Auckland Council
Development Engineer

RE: APPLICATION FOR RESOURCE CONSENT AT 22 & 22A SUMMIT DRIVE

Please find below our response to the to the Civil Engineering items raised by the Council in their Section 92 request dated 16 October 2025.

Appendix A - Private Drainage Asbuilt

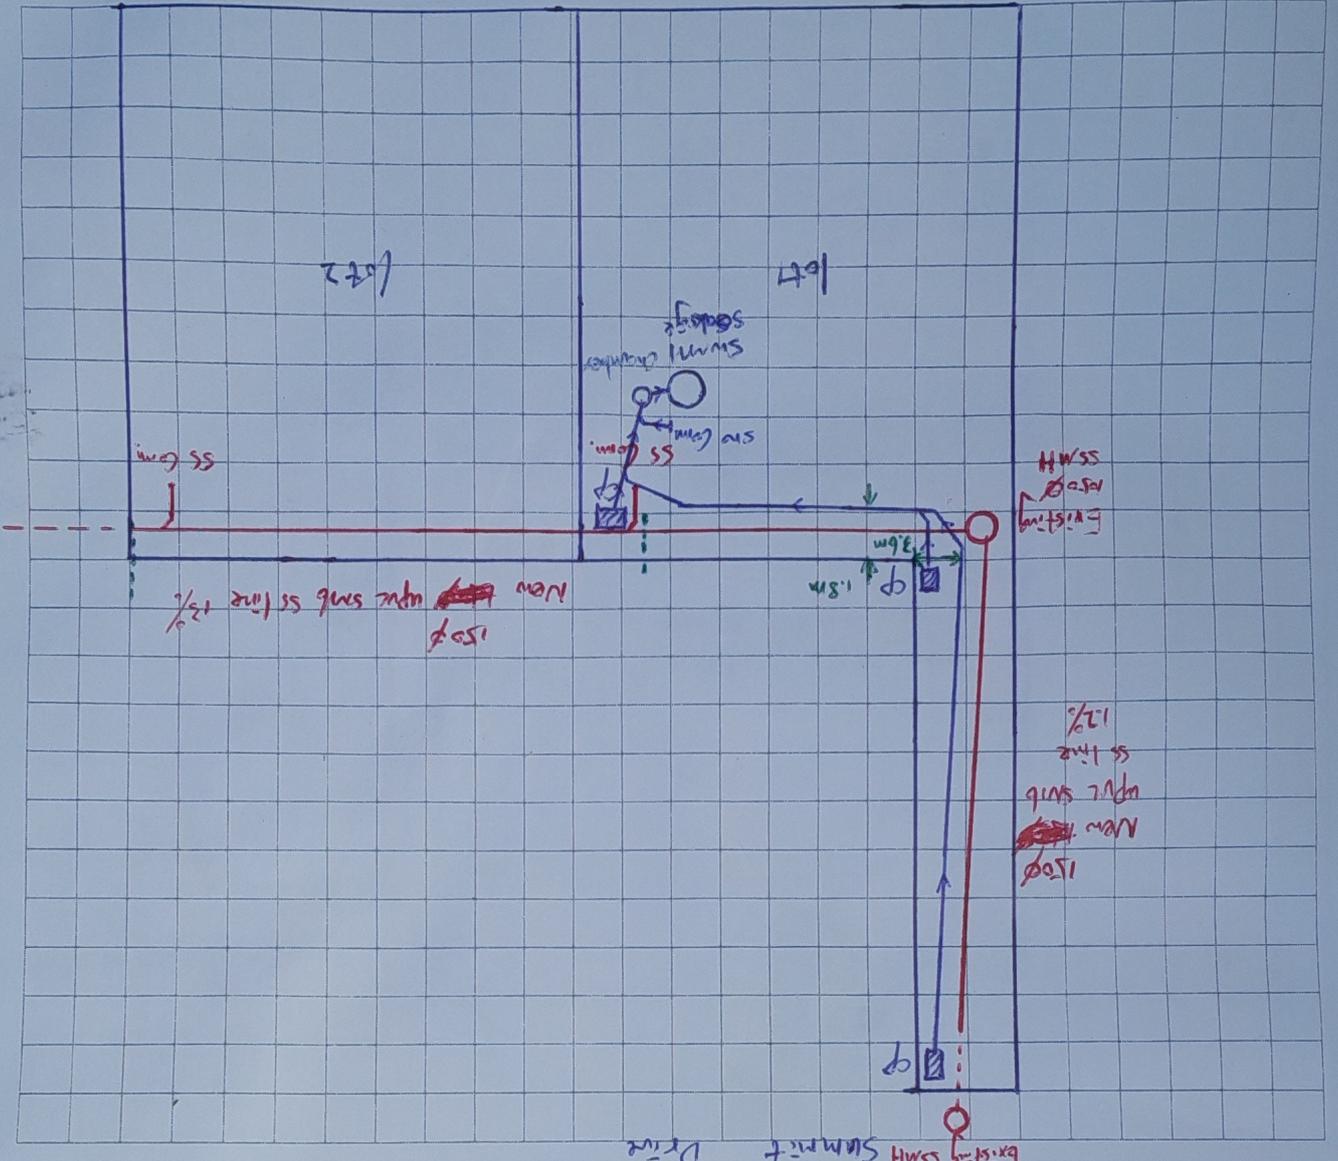
The proposed accessway appears to bypass the detention tank and soakage system. Please confirm how the impervious area from the accessway will be collected and managed.

The existing shared driveway that was constructed as part of the underlying subdivision is serviced by the newly installed deep bore soakage manhole. Please refer to the attached private drainage as built attached in Appendix A of this Letter. The Proposal therefore only includes calculations for all additional impervious area.

Appendix B - RC104 Rev B

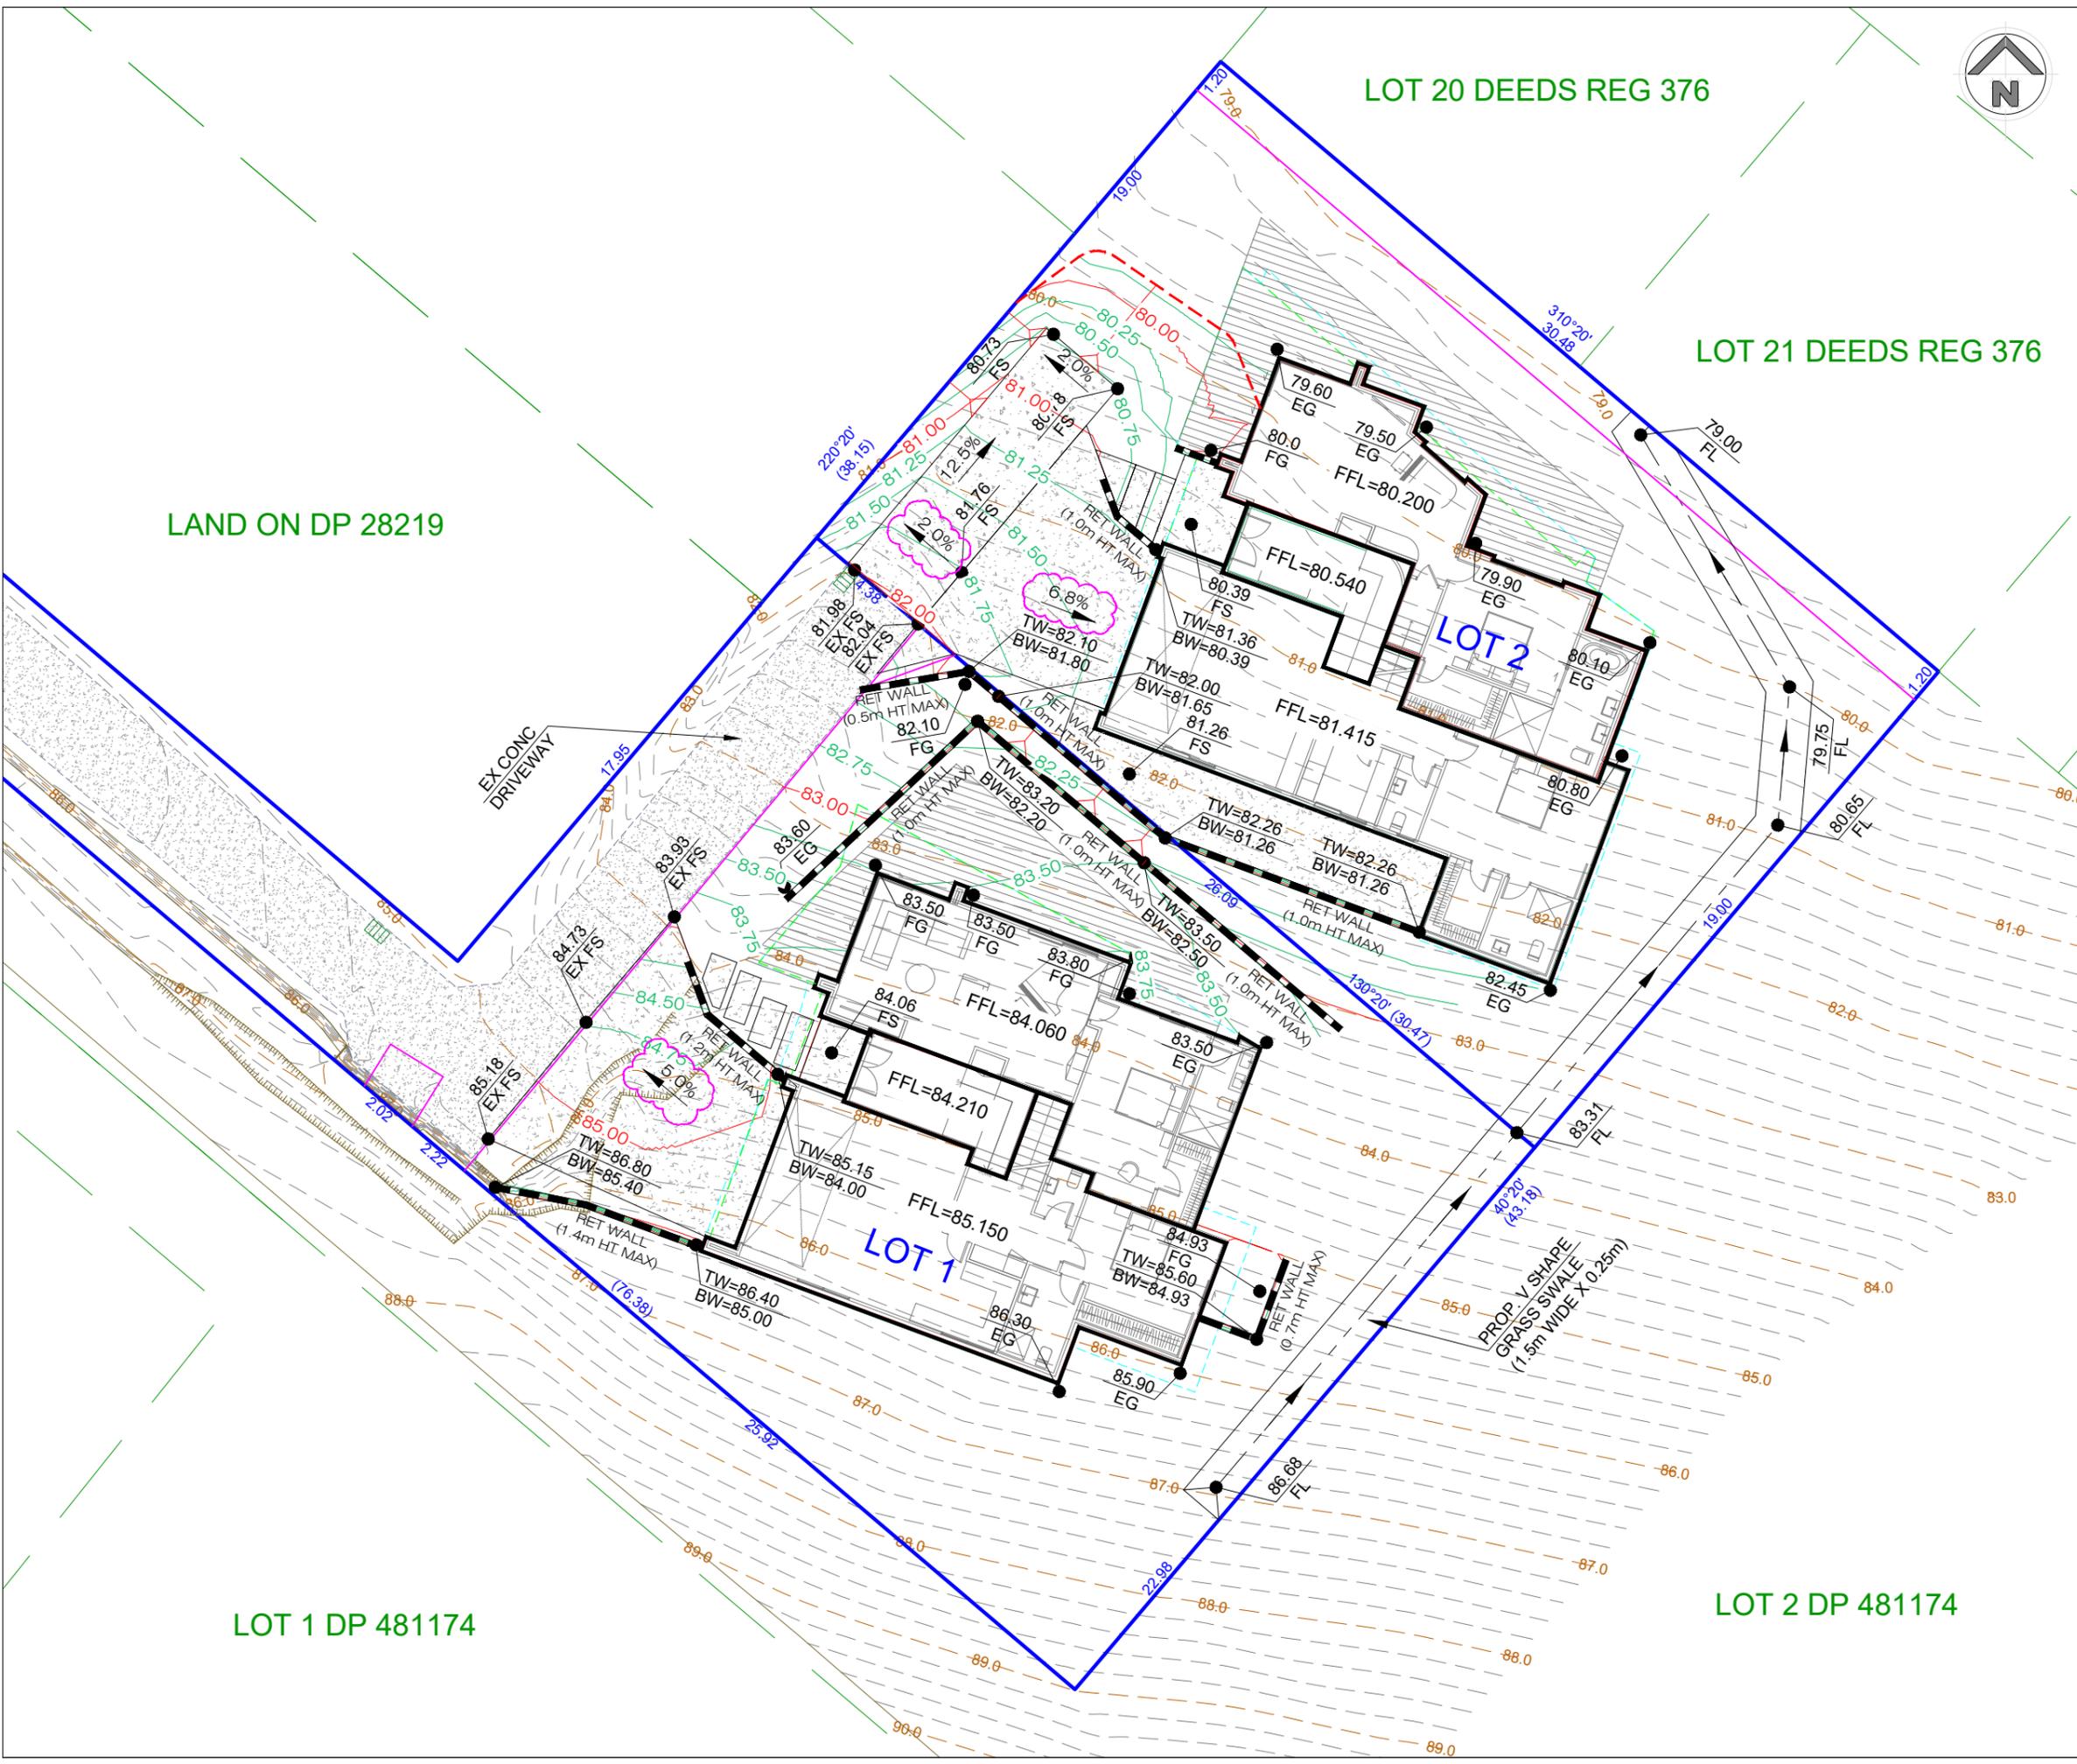
Item 10 – Please provide appropriate long sections to verify compliance with the following Auckland Unitary Plan (OP) standards:

- E27.6.3.6 – Formation and Gradient;
- E27.6.4.4(2) – Vehicle Access Transition Gradient; and
- E27.6.4.4(3) – Vehicle Access Platform

Item 11 – Please demonstrate on the plans the proposed surface gradient for the manoeuvring spaces to demonstrate compliance with standard E27.6.3.6 Formation and Gradient.

Refer to drawing RC 104 Rev B attached in Appendix B of this Letter showing the relevant driveway gradients. CKL has provided relevant transport engineering commentary with respect to compliance.

Refer to drawing RC 104 Rev attached in Appendix B of this Letter showing the relevant driveway gradients. CKL has provided relevant transport engineering commentary with respect to compliance.
